UNITED STATES PATENT AND TRADEMARK OFFICE

APPLICATION NO.	FILING DATE	FIRST NAMED INVENTOR	ATTORNEY DOCKET NO.	CONFIRMATION NO.
09/970,104	10/03/2001	Motohiro Suzuki	SIW-013	1403

Office Action Summary

DETAILED ACTION

The APA'277 teaches a conventional humidifier utilizing a hollow fiber membrane module as follows (SECTION 0003-0006/ Figure 23):

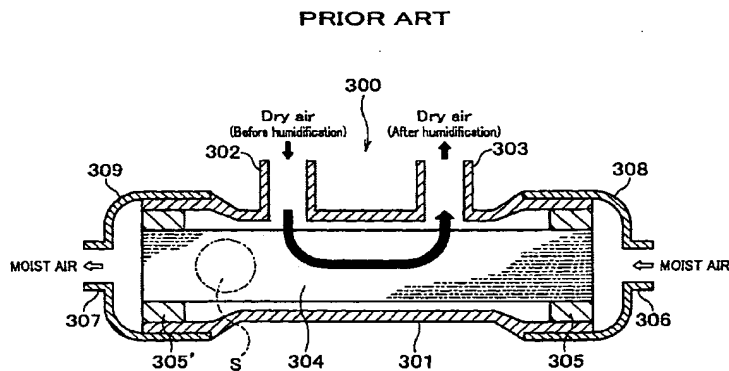
10. Claims 1 and 5 are rejected under 35 U.S.C. 102(b) as being anticipated by applicant's admitted prior art in the US application 09/764277 (*herein after referred to as APA'277*).

As to the specific preamble reciting “for a fuel cell system” and “reactive gas and off-gas flow relationship”, it is pointed out that the preamble and limitations refer to intended use. That is, the claim is directed to “a humidifier” per se and the preamble phrase “for a fuel cell” is only a statement of ultimate intended utility.

Further, given that no specific fuel cell structure has been positively claimed, it is also contended that the recited flow relationship of both the reactive gas and the off-gas is an ultimate utility. Thus, since the APA’277 does encompass flowing gases each having a different moisture content inside and outside the hollow fiber membrane, it is contended that the APA’277 satisfies the requirement of having both gases i.e. the reactive gas and the off-gas themselves.

It is also noted that the examiner has interpreted that “the liquid exhaust mechanism which exhausts liquid” can be the same “reactive gas exit” itself or “the off-gas exit” as such,

because they are able to exhaust liquid which has been generated therethrough. In that, the "reactive gas exit" and/ or "the off-gas exit" are inherently recited by the claim because gas entrances and exits are necessarily required in order to supply and remove the gas from the humidifying unit.

Thus, claims 1 and 5 are anticipated.
